SOUTH VALLEY WATER RECLAMATION FACILITY
PROJECT 4D
WEST JORDAN, UTAH

MECHANICAL
BIOREACTOR NO. 4 AIR
DIFFUSER SYSTEM PLAN

SOUTH VALLEY WATER RECLAMATION FACILITY		
WEST JORDAN UTAH		
THIS DRAWING IS THE PROPERTY OF SANITAIRE AND IS SUBMITTED IN CONFIDENCE. IT IS NOT TO BE REPRODUCED, COPIED OR DUPLICATED WITHOUT PERMISSION OF SANITAIRE.		
BIOREACTOR 1-4 STRUCTURAL, DROPLEGS & MANIFOLDS KEY PLAN		
ITT Corporation		
SANITAIRE® BROWN DEER, WISCONSIN 53223 ABJ®		
DRAWN BY: MRL	DATE: 12-4-07	DESIGN: NEW/REV
CHKD BY: MTR	DATE: 12-12-07	STD.
APPROV BY: DE	DATE: 12-13-07	SHEET: 2 OF 40
JOB: 07-67425		
S-2

BIOREACTOR 1-4
AERATION GRIDS
KEY PLAN

GRID TYPE '4B

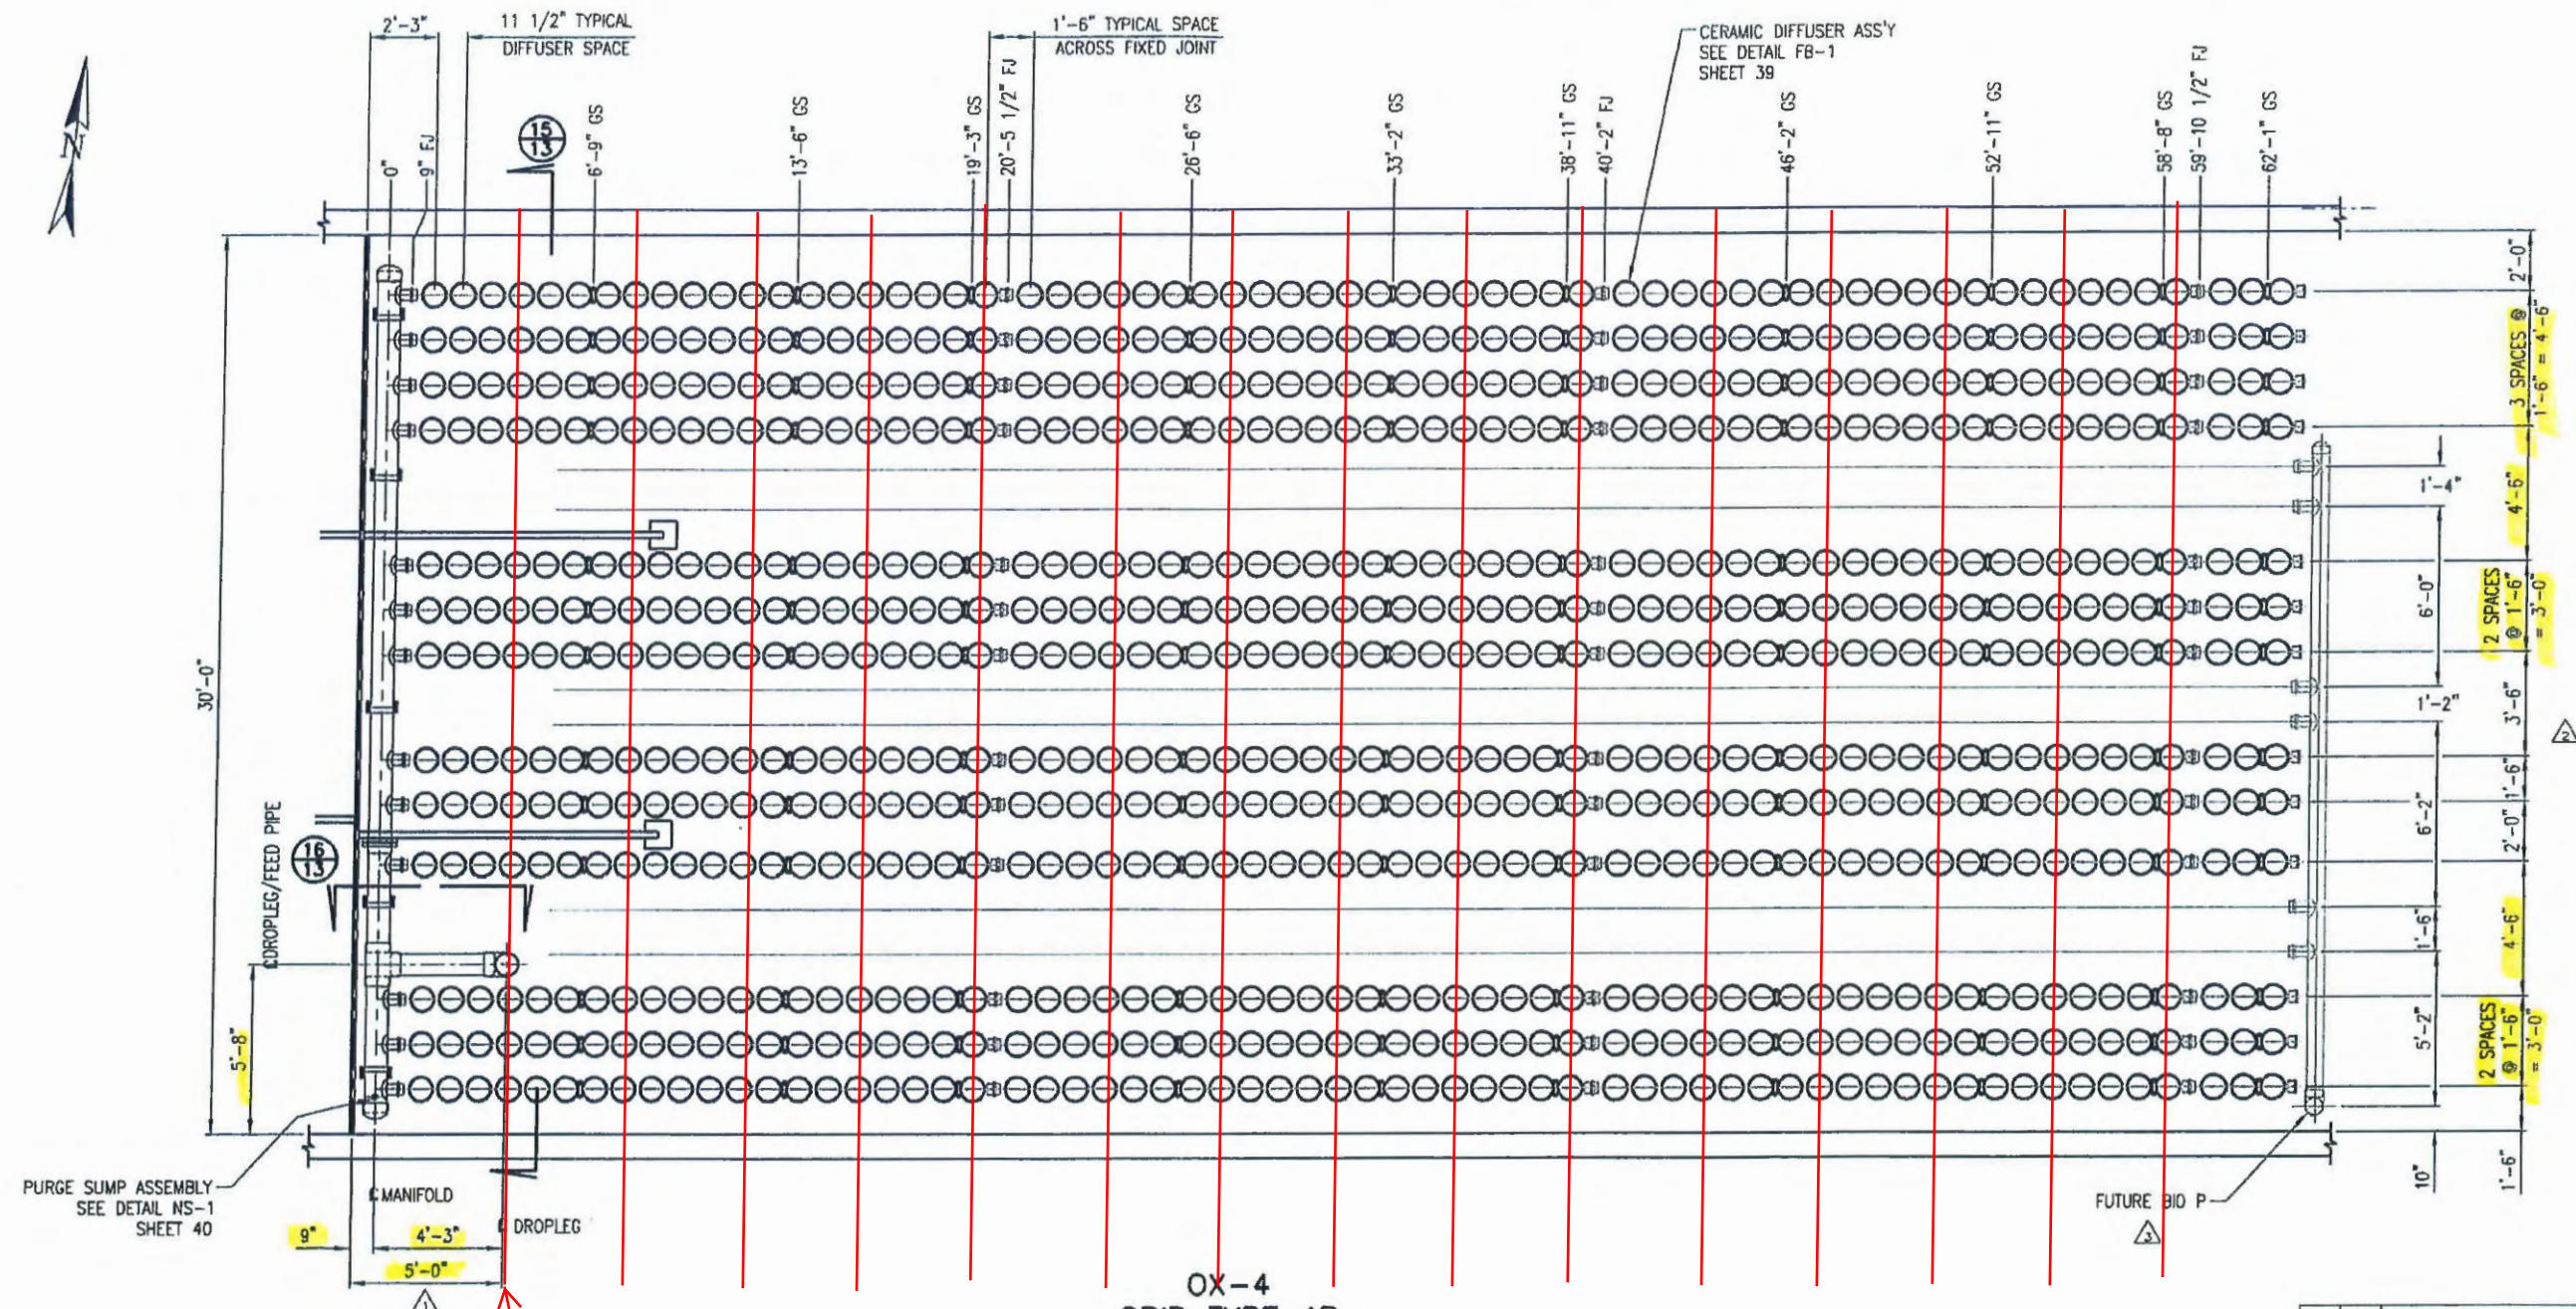
- 1) REMOVE 195 CERAMIC DIFFUSERS AND ASSOCIATED O-RINGS AND PVC RETAINER RINGS. INSTALL NEOPRENE PLUGS IN ORIFICE HOLES AND LEAVE DIFFUSER HOLDERS EMPTY AS INDICATED BY RED LINES. FINAL EPDM MEMBRANE DIFFUSER COUNT IN THIS GRID IS 624. TYPICAL BOTH BIOREACTORS.
- 2) PROVIDE AND INSTALL EPDM MEMBRANE DIFFUSERS WITH PVC SUBPLATES TO REPLACE ALL OTHER EXIST CERAMIC DIFFUSERS. TYPICAL BOTH BIOREACTORS.

OX-5A
GRID TYPE 5
PLAN VIEW

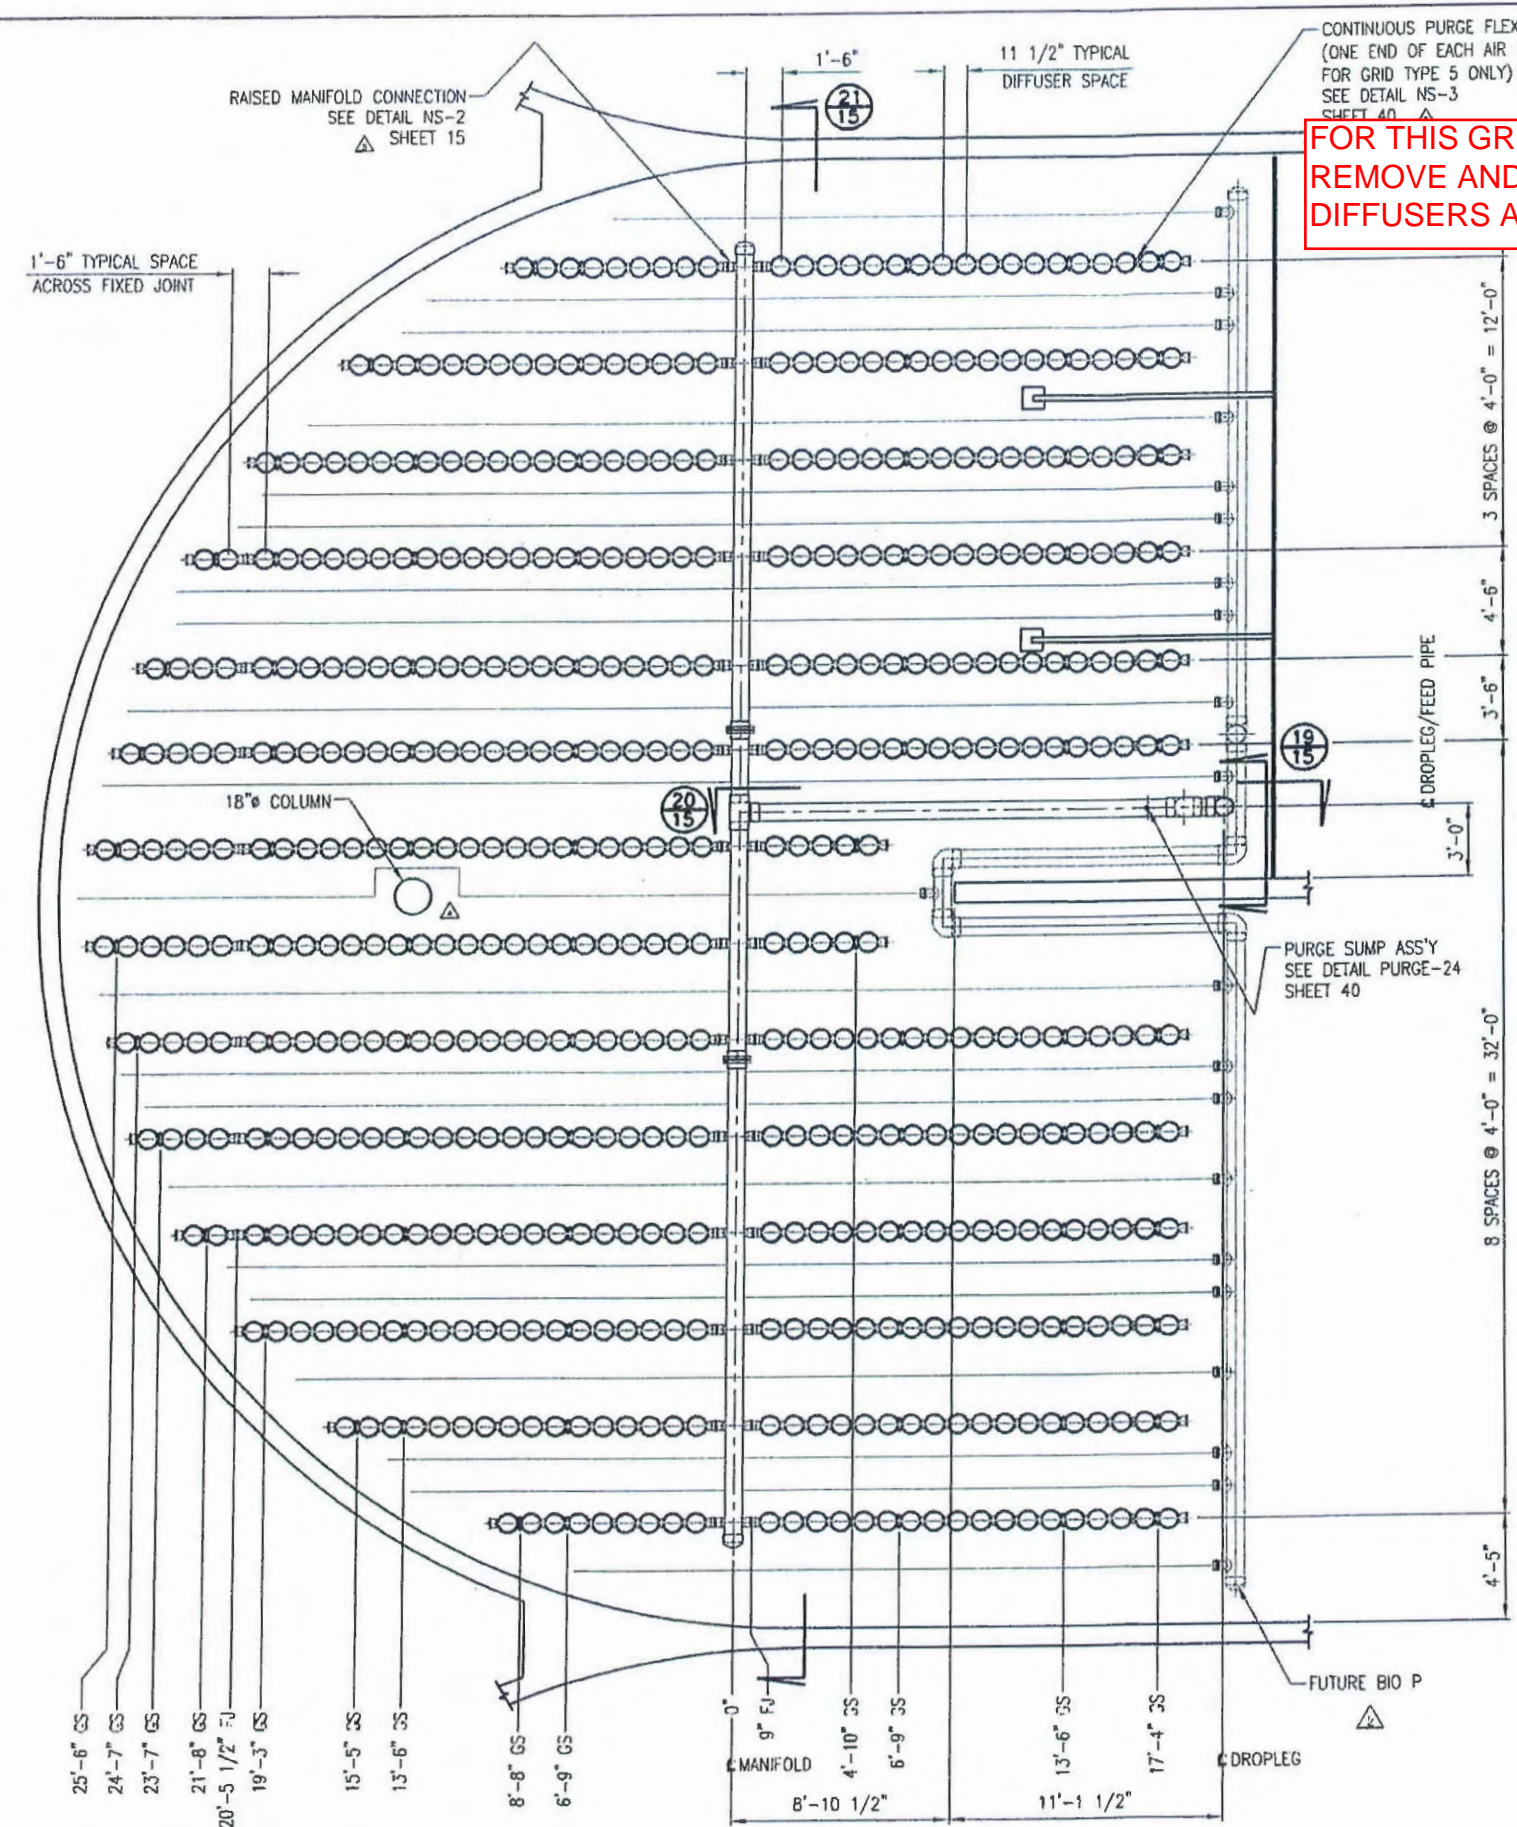
FOR THIS GRID:
REMOVE AND REPLACE ALL CERAMIC DIFFUSERS WITH EPDM MEMBRANE
DIFFUSERS AND PVC SUBPLATES. TYPICAL BOTH BIOREACTORS.

OX-5B
GRID TYPE 6A
PLAN VIEW 22

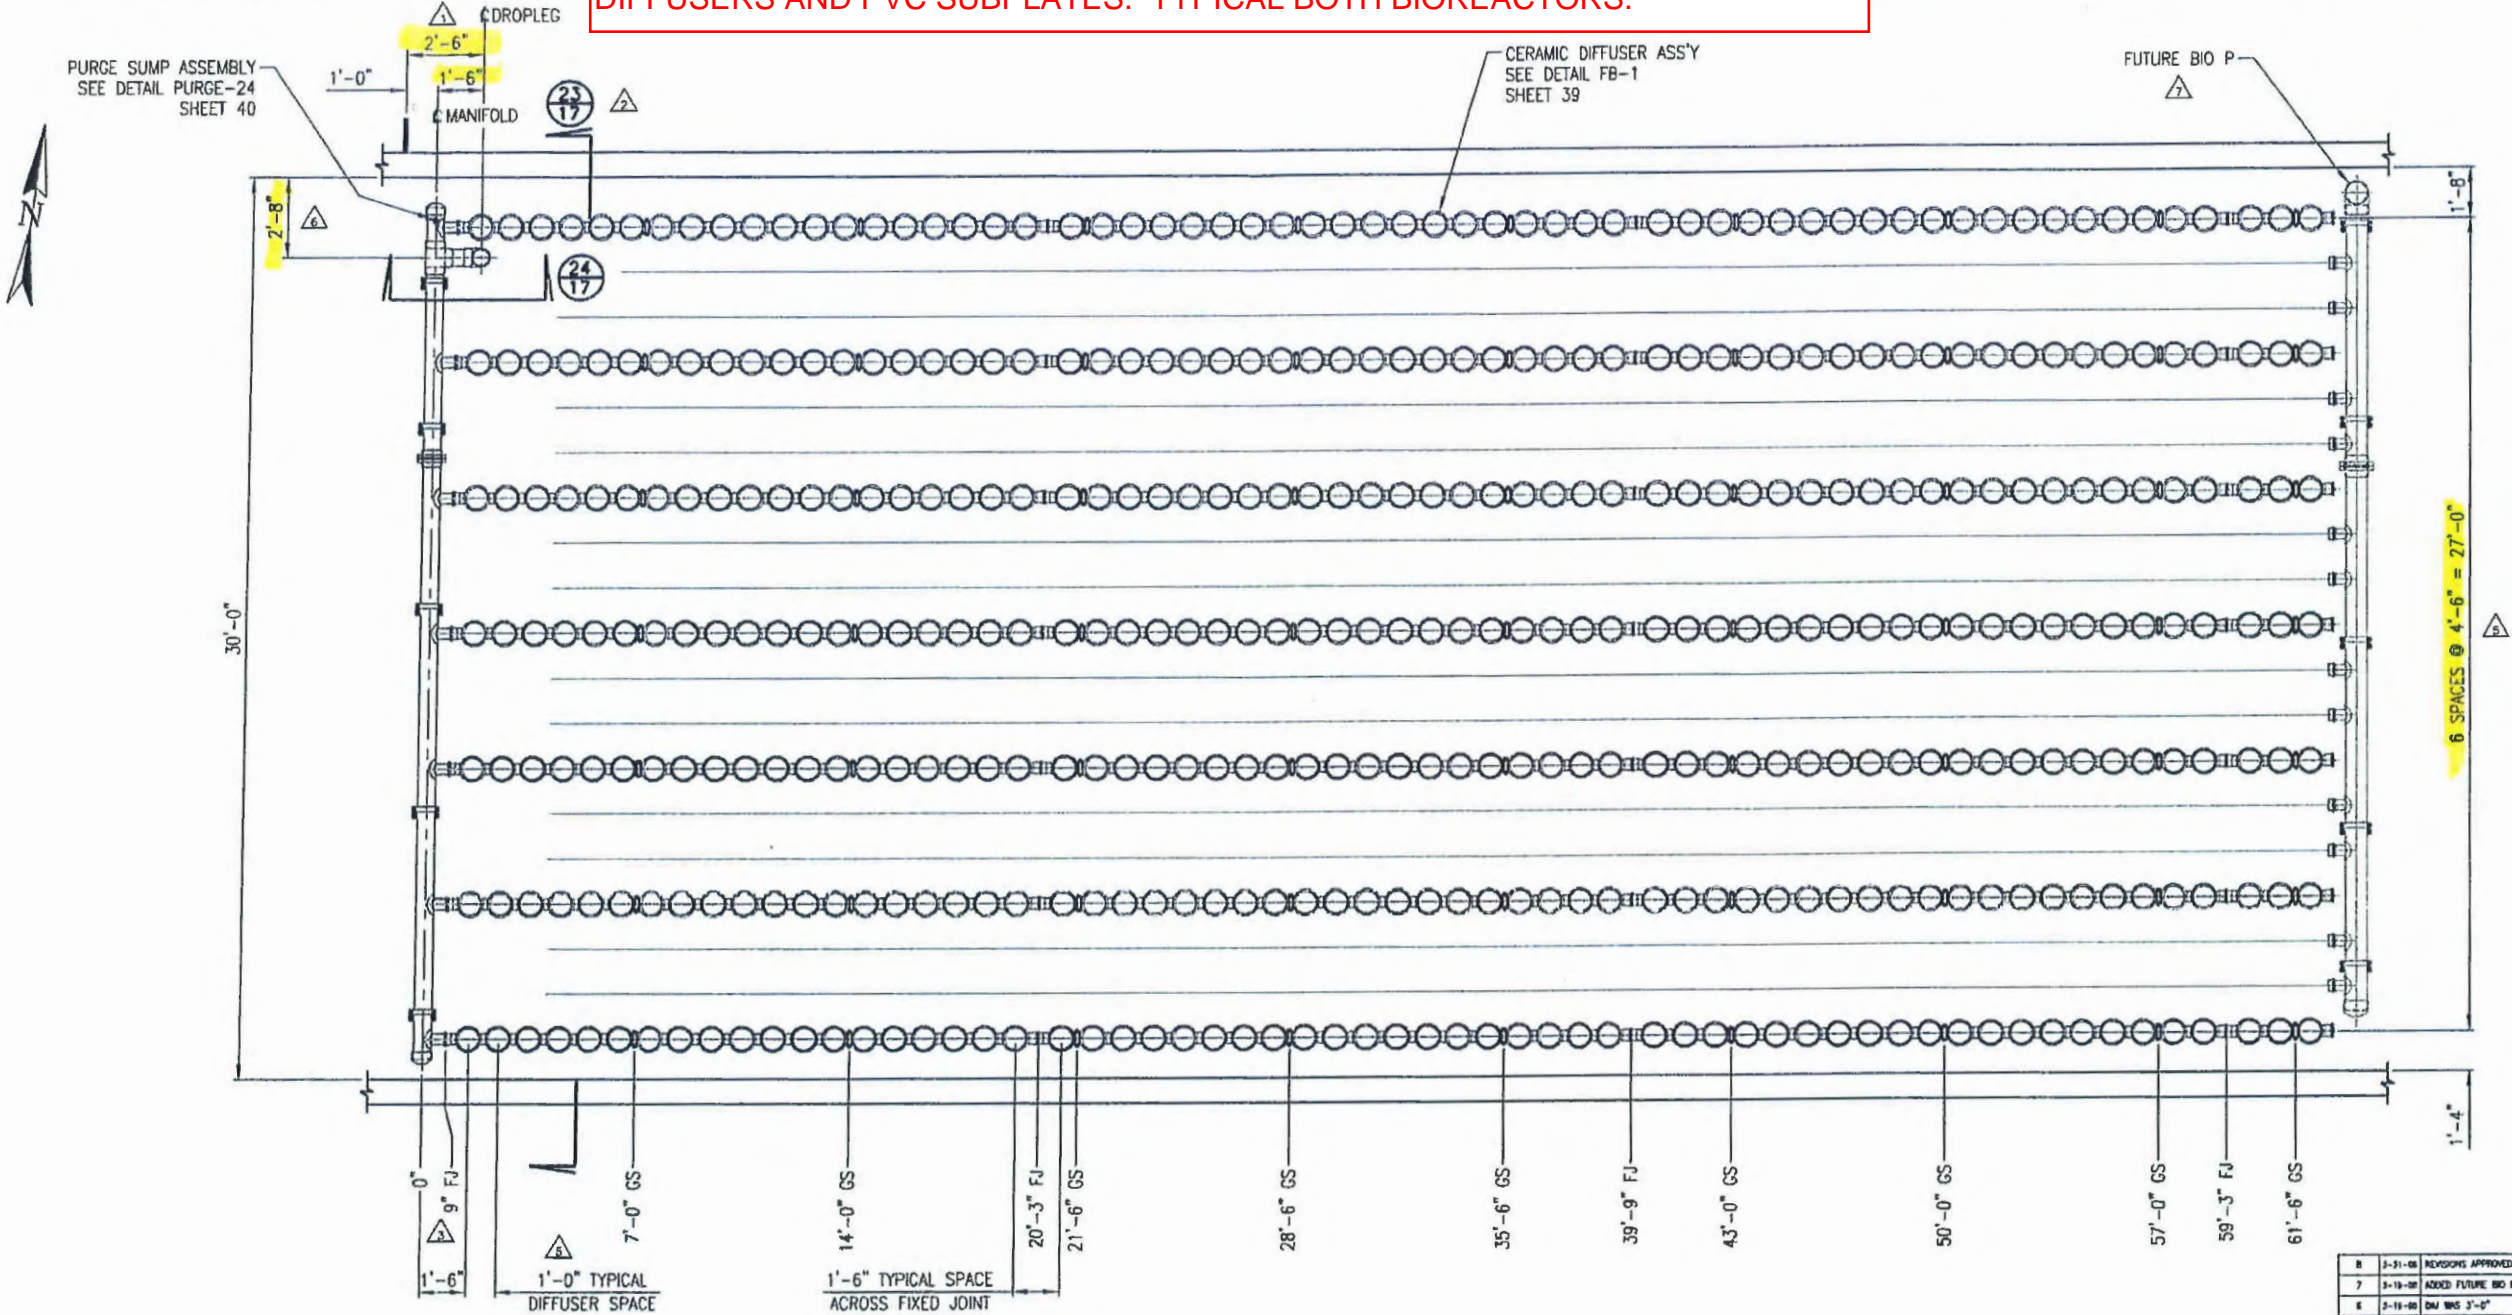
FOR THIS GRID:
REMOVE AND REPLACE ALL CERAMIC DIFFUSERS WITH EPDM MEMBRANE
DIFFUSERS AND PVC SUBPLATES. TYPICAL BOTH BIOREACTORS.
